Lower Lee (Cork City) Flood Relief Scheme (Drainage Scheme)

Exhibition Report

Office of Public Works

Issue to website | 5 December 2017

Figure 59: Plan of Alternative Solution for Sullivan's Quay

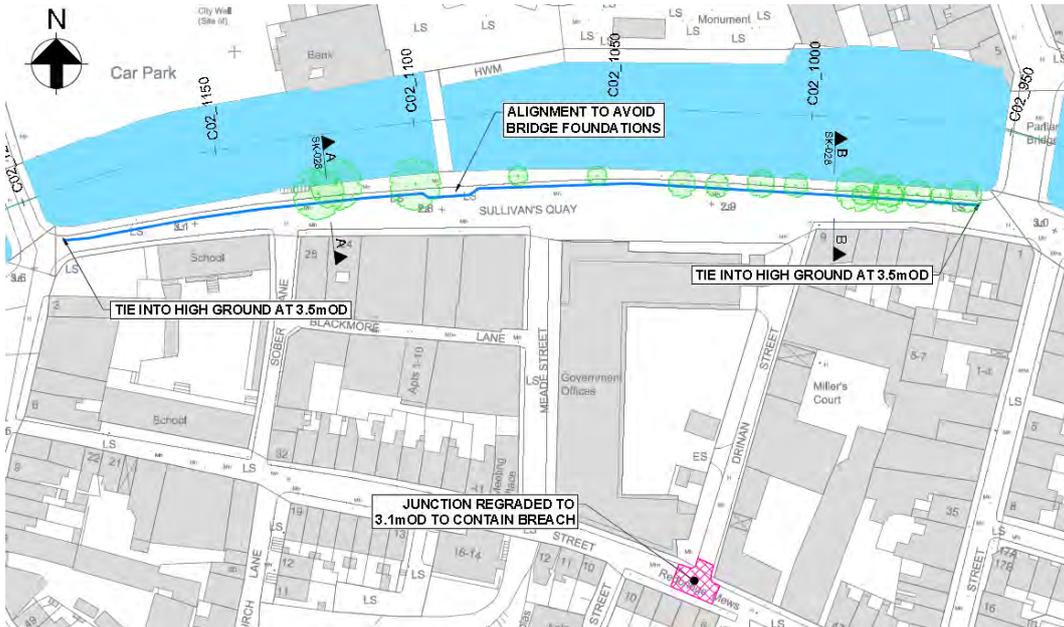
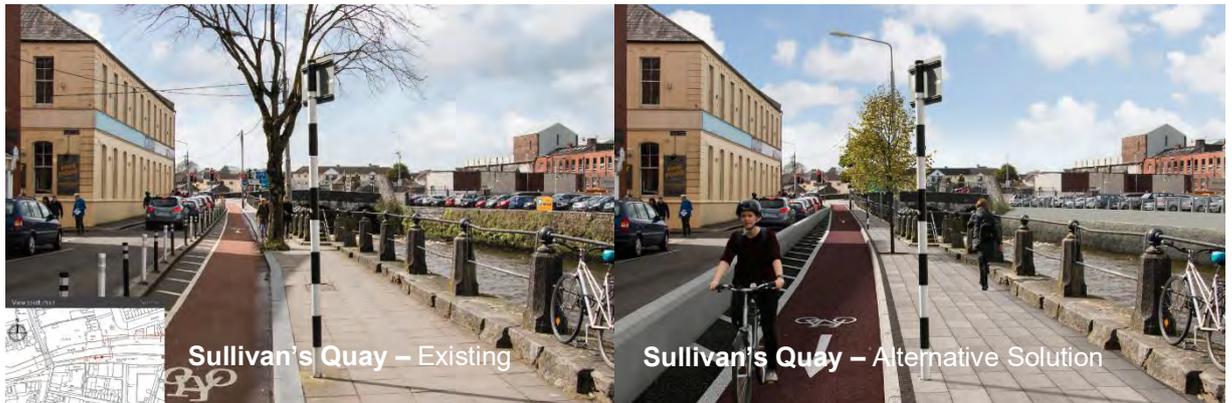
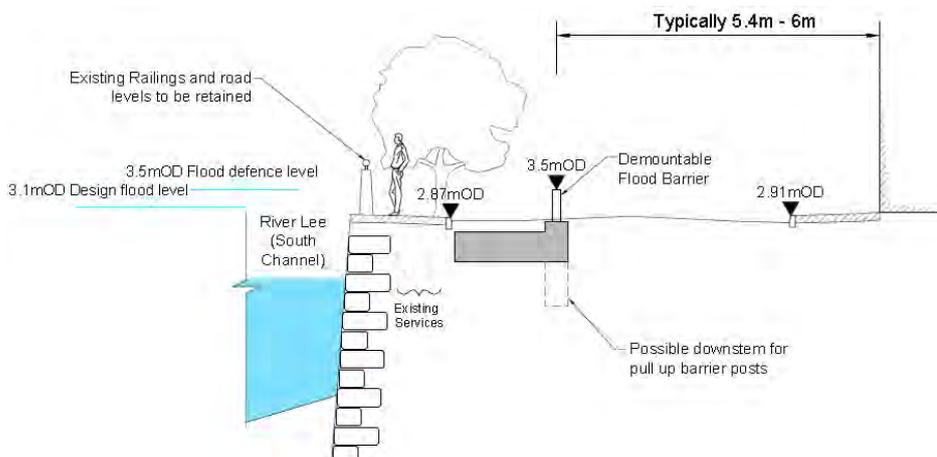
In light of the submissions received for this area, the Design Team has again reviewed this area and, in close consultation with Cork City Council, has proposed an alternative solution which ensures the existing historical railings and the quays close connection to the river is maintained. As was made clear by stakeholder comments during the public consultation, Sullivan's Quay is a highly sensitive area. In order to maintain the historic railings, a solution involving demountable defences is now proposed as shown in Figure 59, Figure 60 and Figure 61 below.

It should be noted that the details, finishes and look-and-feel of the solution will be finalised during the detailed design stage with input from the project landscape architect, conservation architect and Cork City Council.

Figure 62: Plan of Proposed Defence Alignment along South Mall Properties

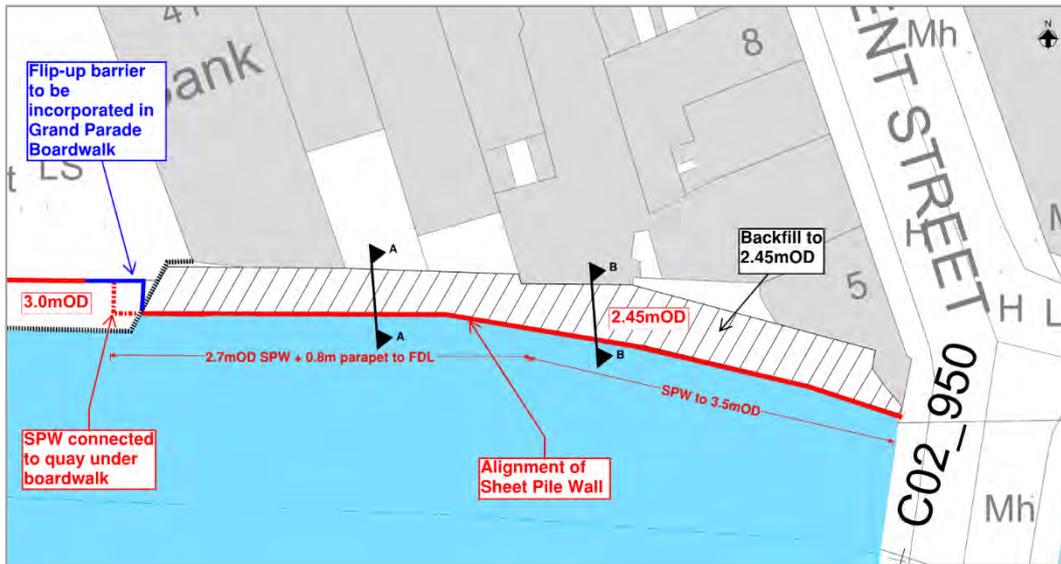
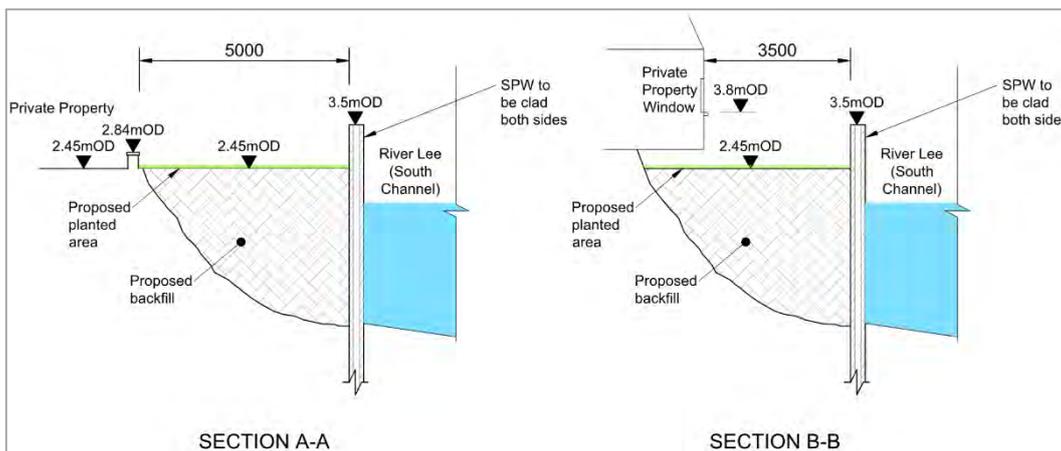
Refer to Figure 62 and Figure 63 below for details of the alternative proposal.
